<b>TCP/11/16(477) – 17/00334/IPL – Residential development (in principle), site of former 1 Lower Gauls, Bankfoot</b>
---

# NOTICE OF REVIEW

**PLANNING APPLICATION REF 17-00334-IPL - DEMOLITION OF DWELLINGHOUSE AND ERECTION OF 2NO. DWELLINGHOUSES (IN PRINCIPLE), 1 LOWER GAULS, BANKFOOT: OBJECTION ON FLOOD RISK GROUNDS**

**Flood Mapping - Existing case  
1 in 25 year event  
(25% Bridge Blockage)**

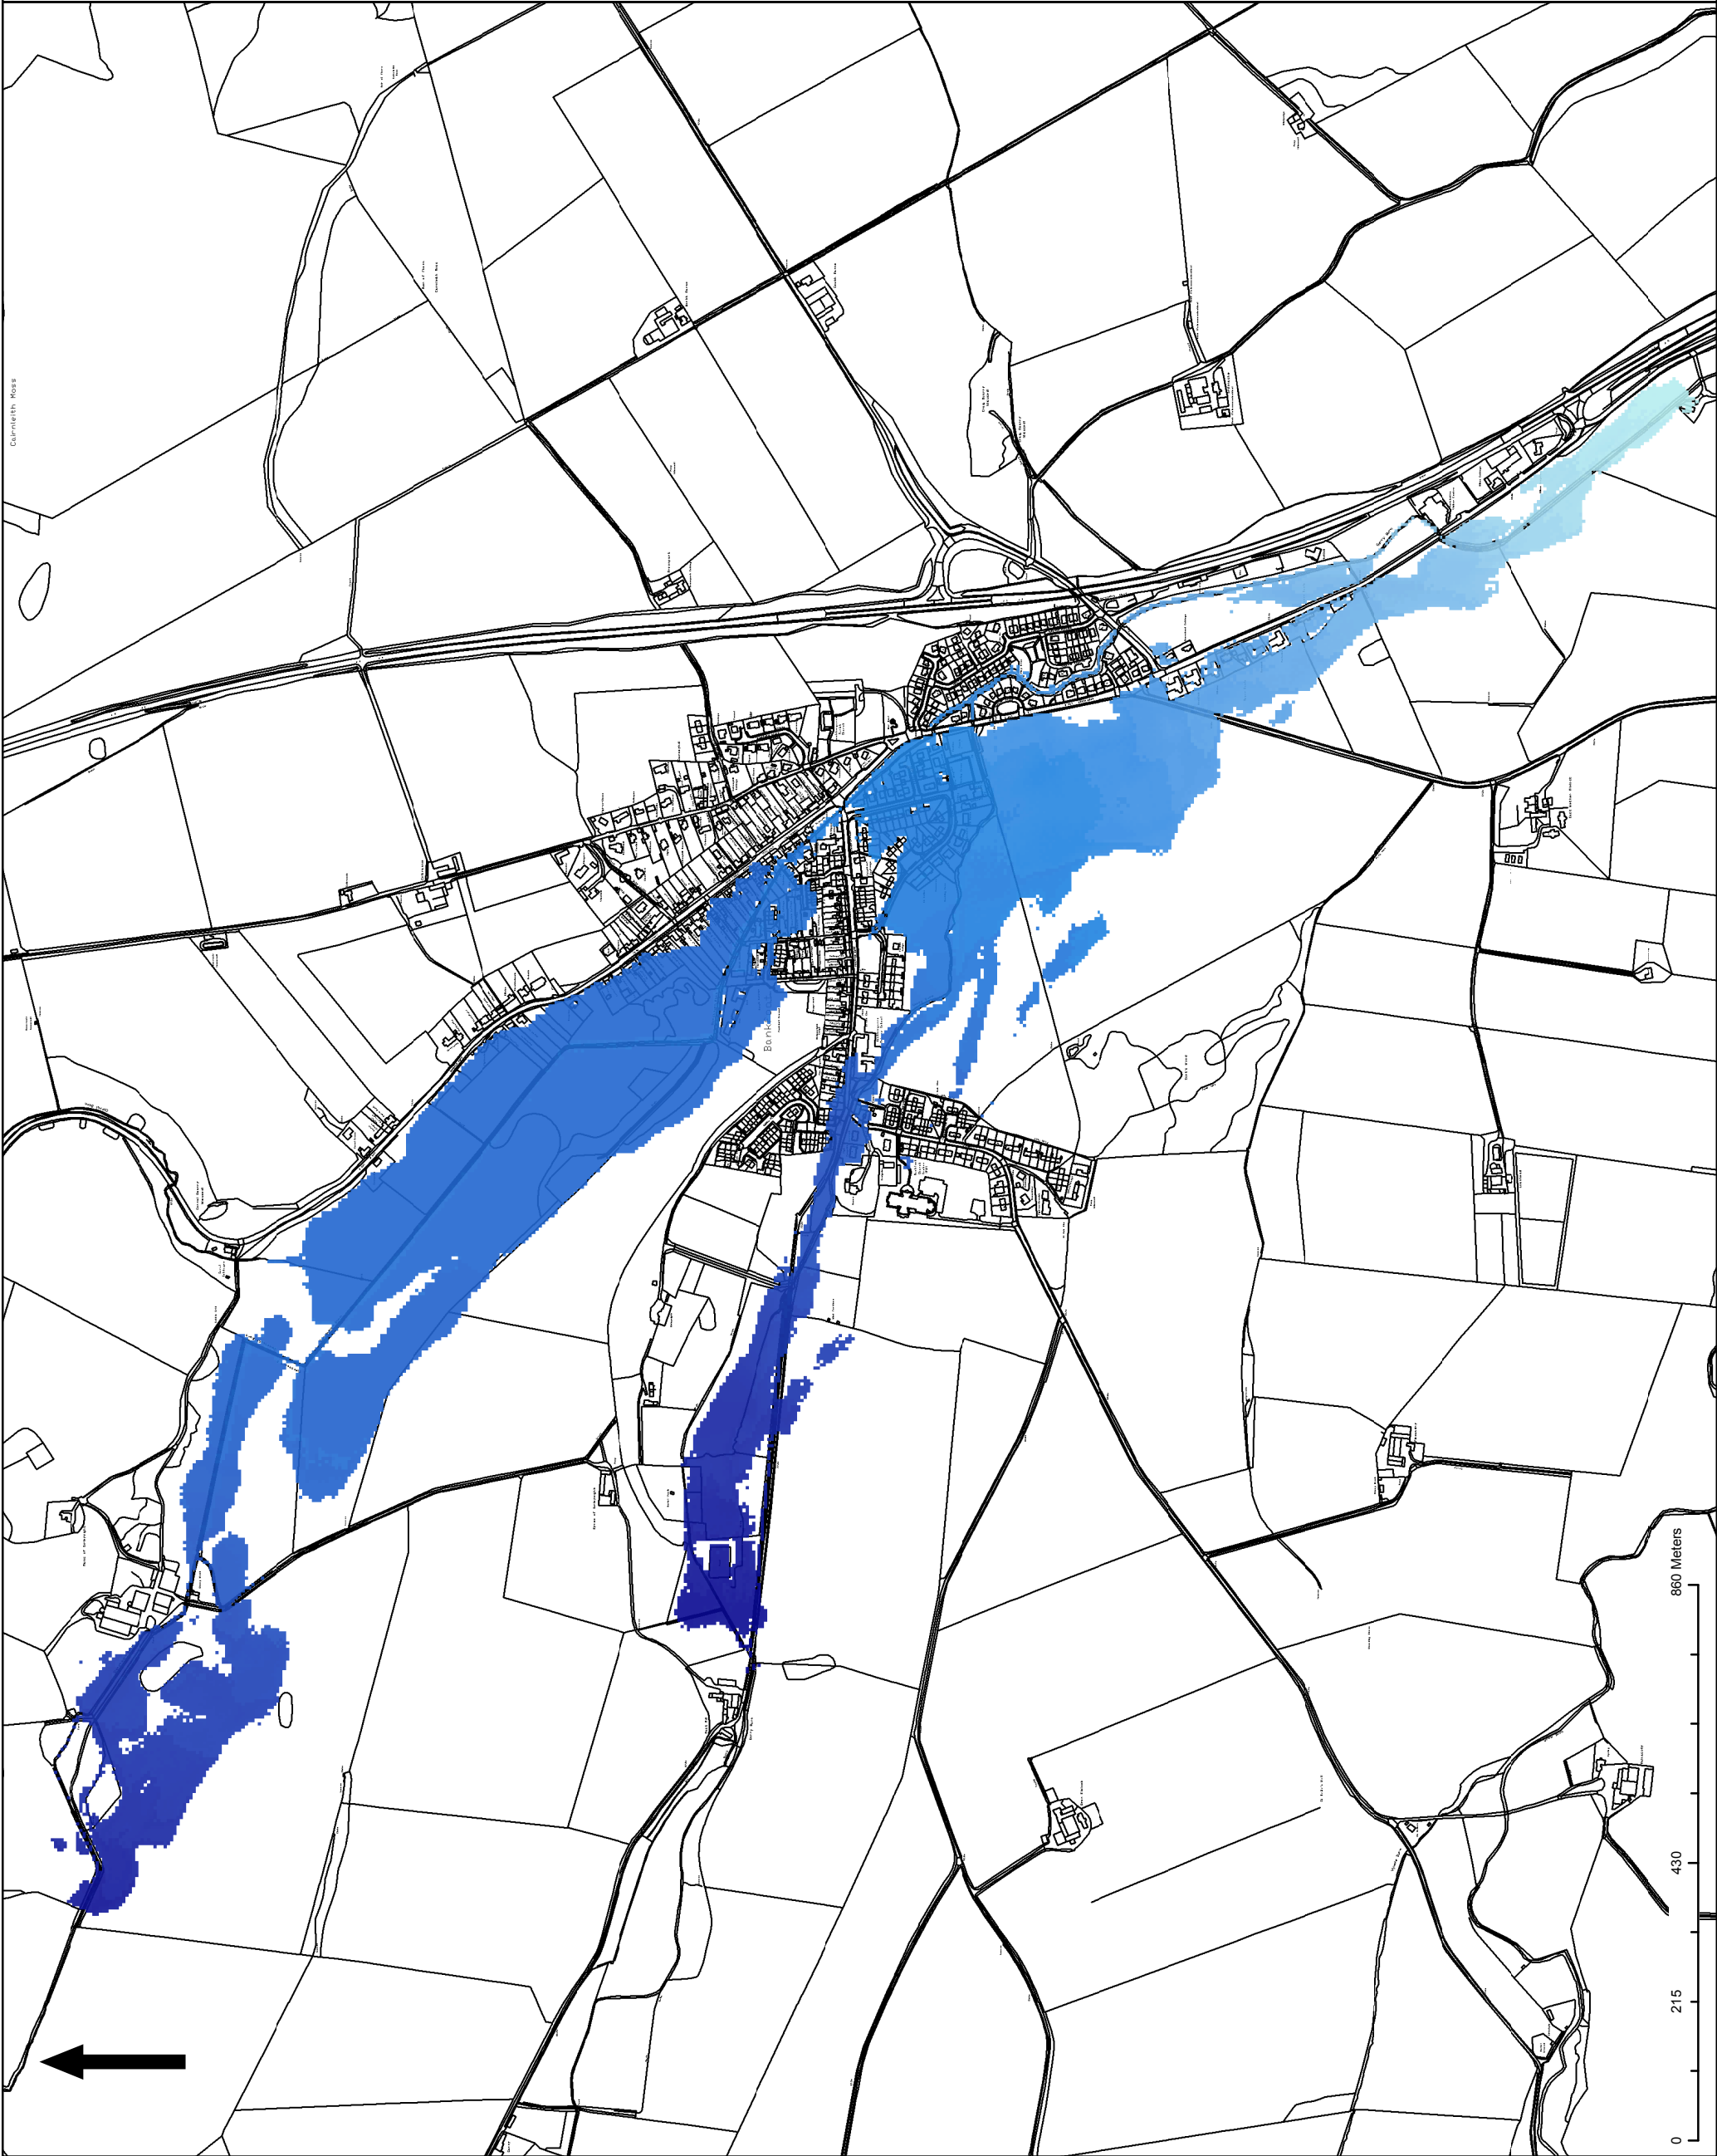
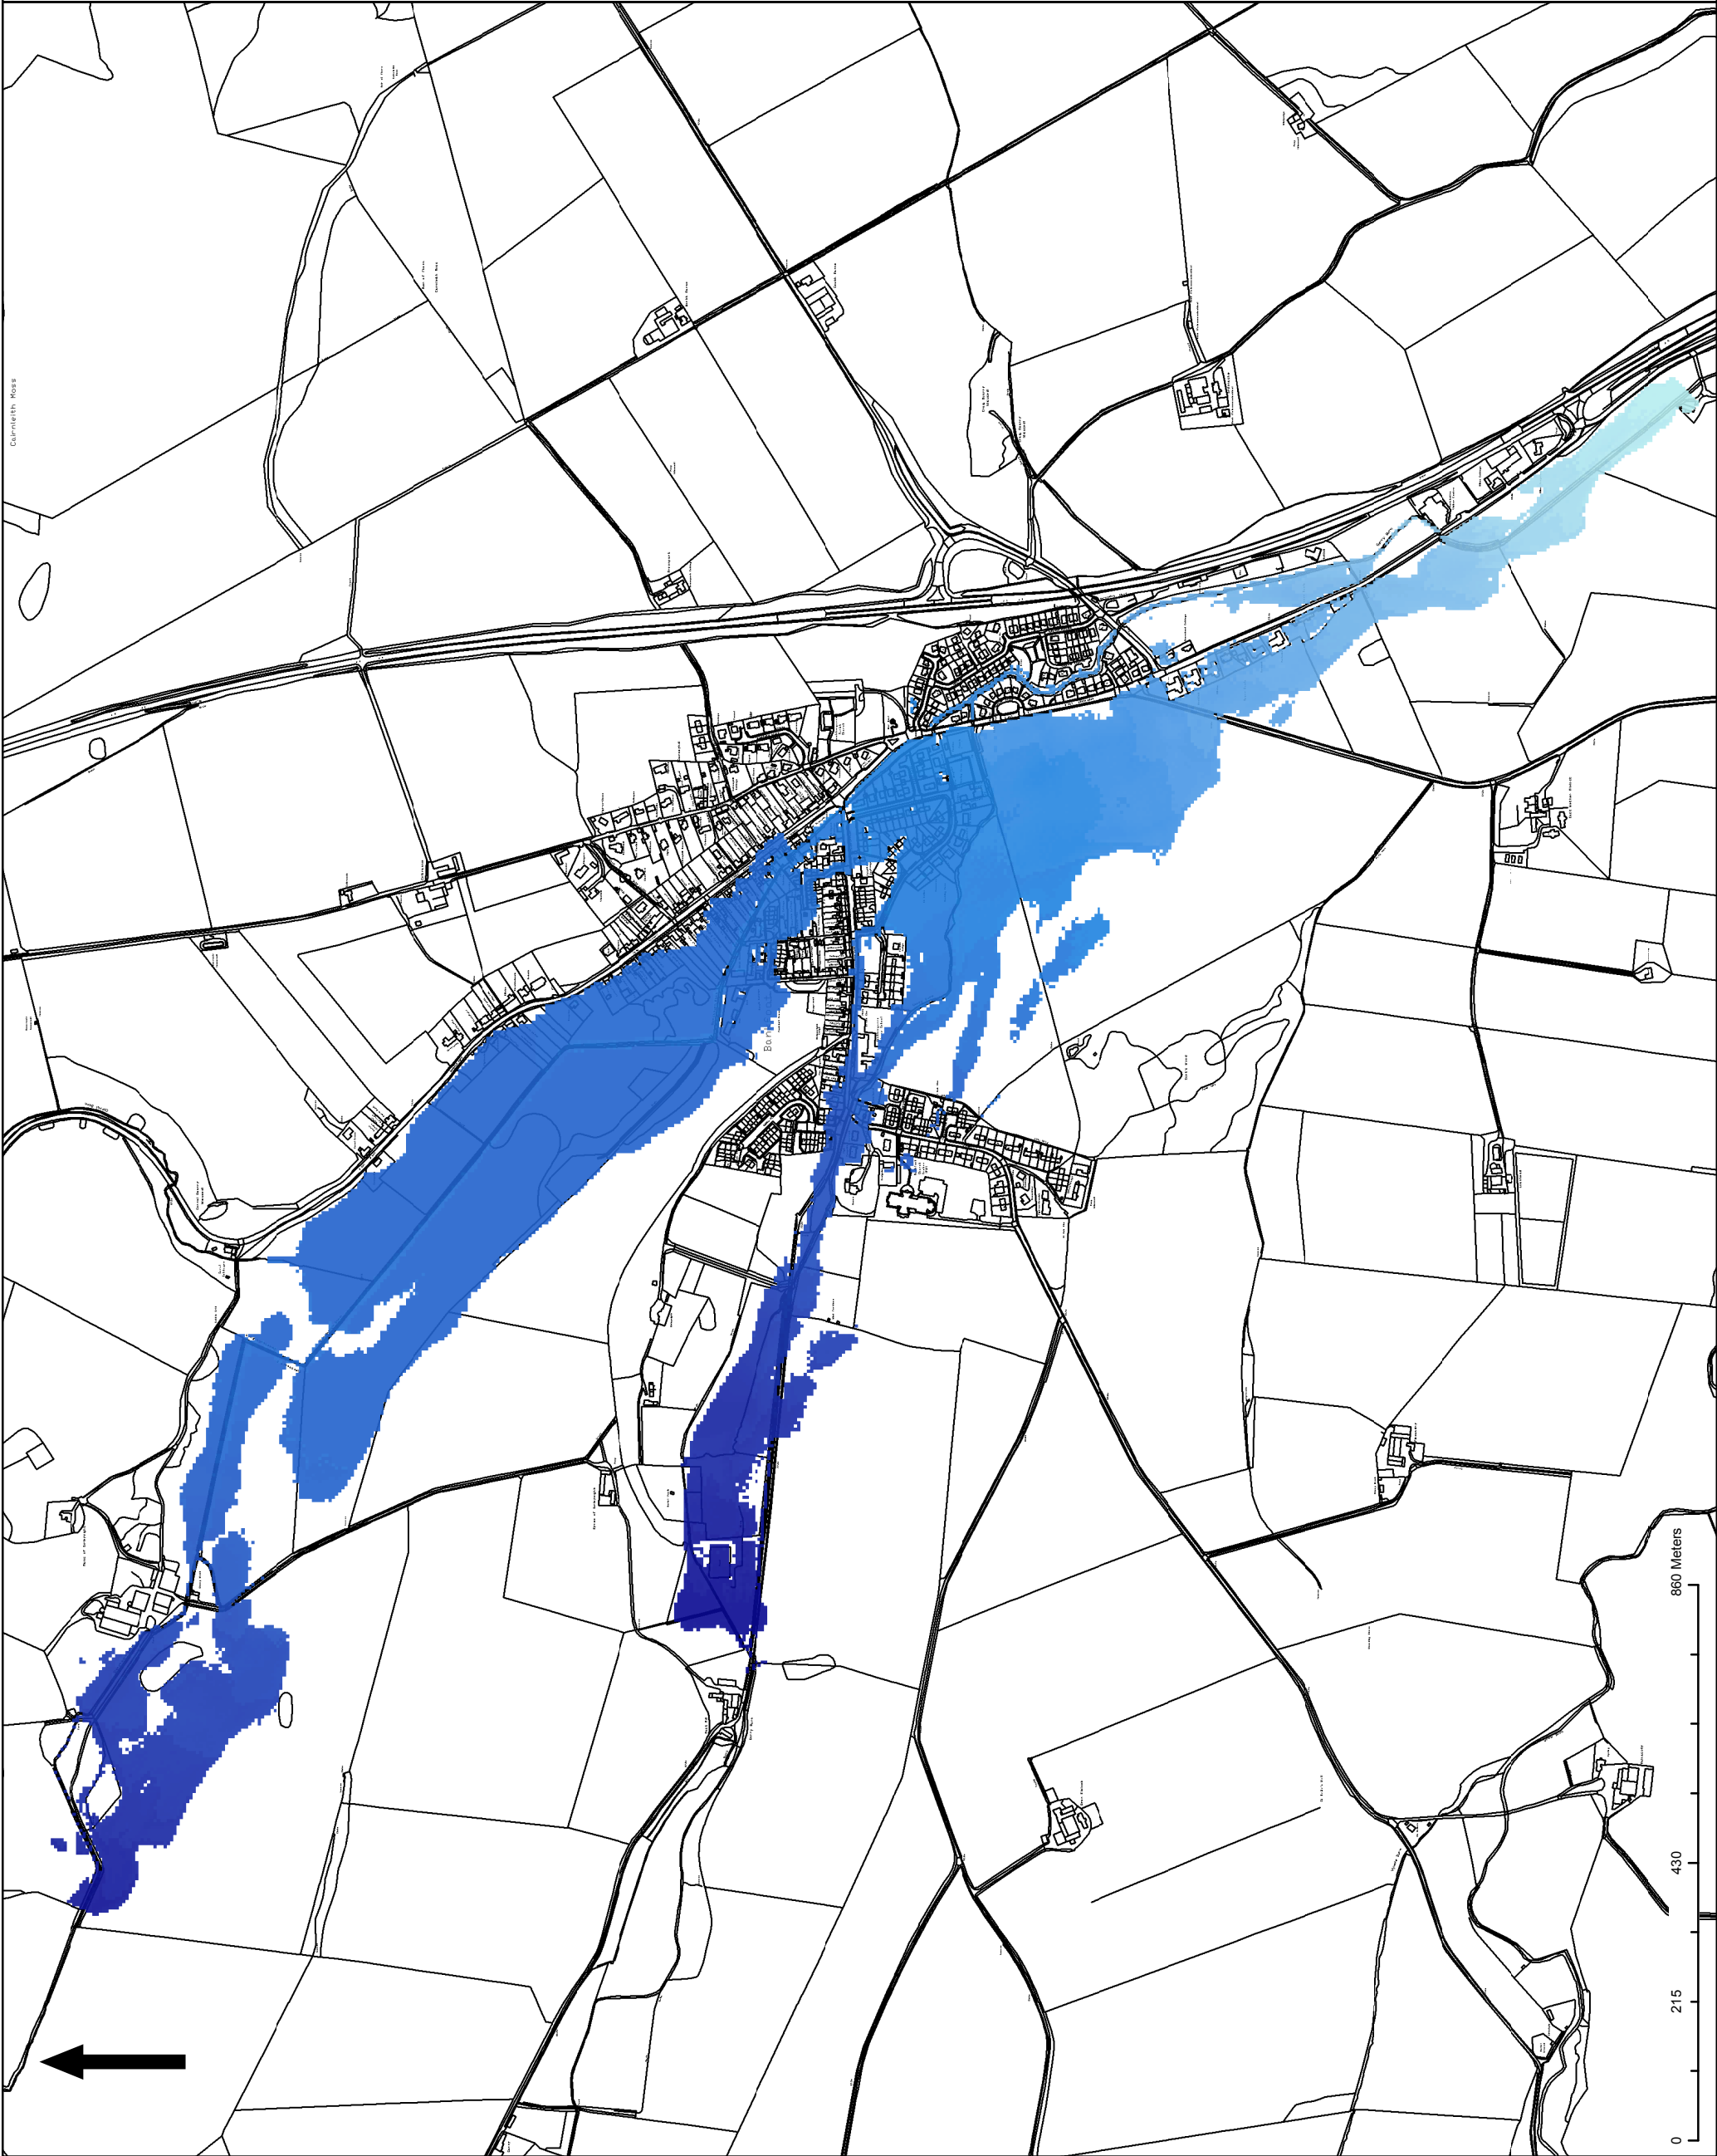
Regarding previous applications the flooding team has been consistent in its objections for the development of this site and those adjacent. The Planning department were also made aware of the delay on our side in referring the application to consultants. The decision from planning came after our response (dated 19/04/17).

To conclude, we are of the opinion that the site is part of the functional floodplain and is not suitable for the development being proposed. The applicant has not provided sufficient evidence to demonstrate the site is suitable for landraising and additional development. I trust this confirms the PKC flooding team's position on this application.
